Subject: FAO Nicholas Coombes. Suggested location for accompanied site visit - A14 Scheme. Our client Mr Robert Lenton as Tenant of Church Commissioners, Corpus Christi Farm, Godmanchester - Representation No.10030881. Our Ref L905

Drawing title: **GENERAL ARRANGEMENT REGULATION 5(2)(o) SHEET 14 OF 24**

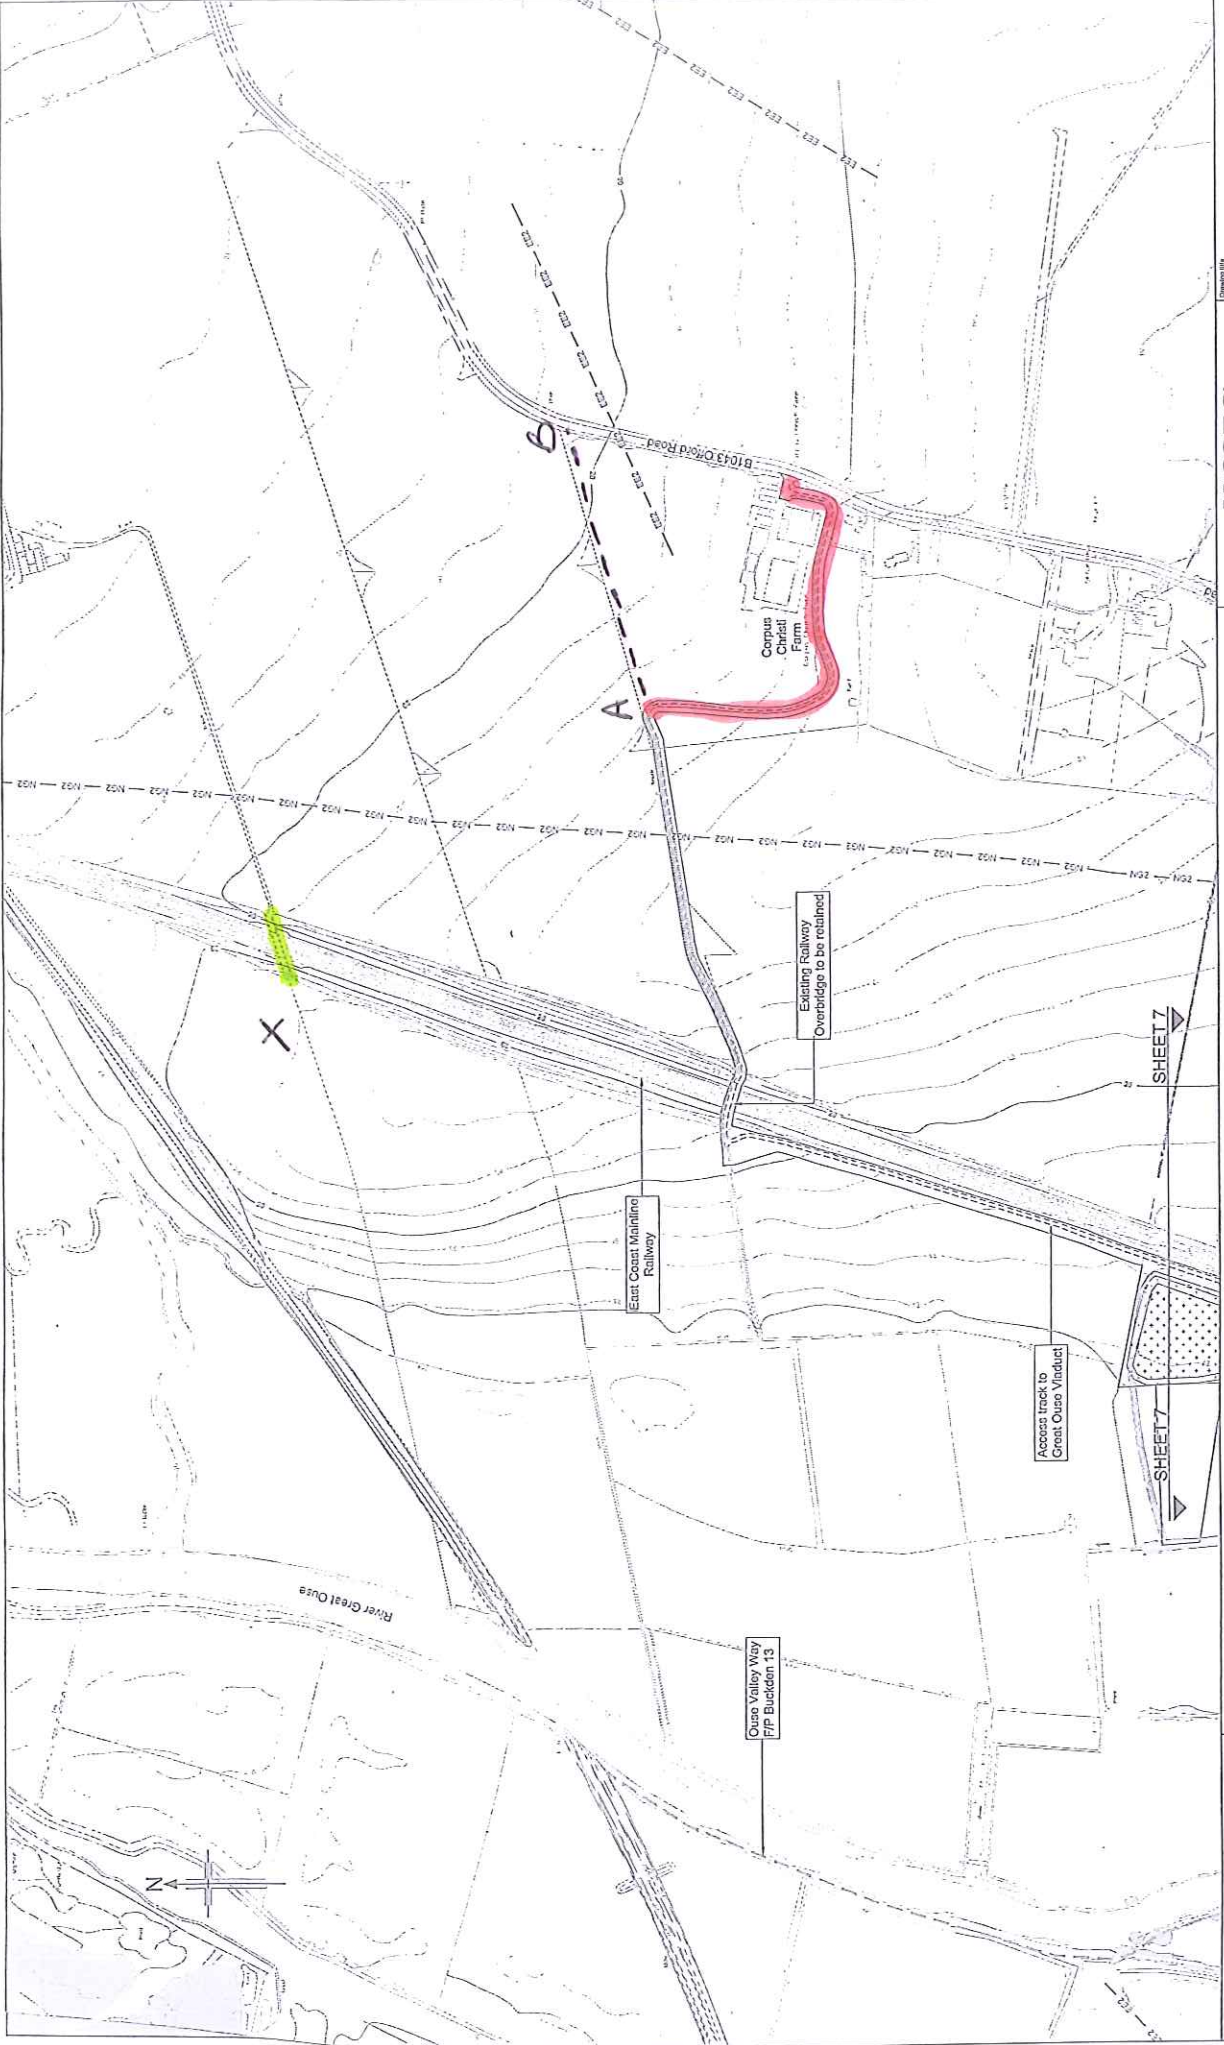
The purpose of this email is to request a site visit to Corpus Christi Farm for the purpose of inspecting the proposed access track to link the B1043 Offord Road to the Great Ouse viaduct as identified coloured pink on General Arrangement Sheet 14 of 24 (copy attached).

In particular our client wishes the Inspectors to understand the nature of the ground over which the track is to be constructed (ridge and furrow pasture) and the inadequacy of the layout for the purpose proposed and to consider possible alternative routes:

- (1) Our client wishes any route to avoid the working farm premises at Corpus Christi Farm and proposes a revised access between points A & B.
- (2) Our client wishes to draw the Inspectors attention to the narrow width of the railway access bridge at the proposed location and to point out a new railway bridge of greater width exists at point X on the plan over an existing access road.
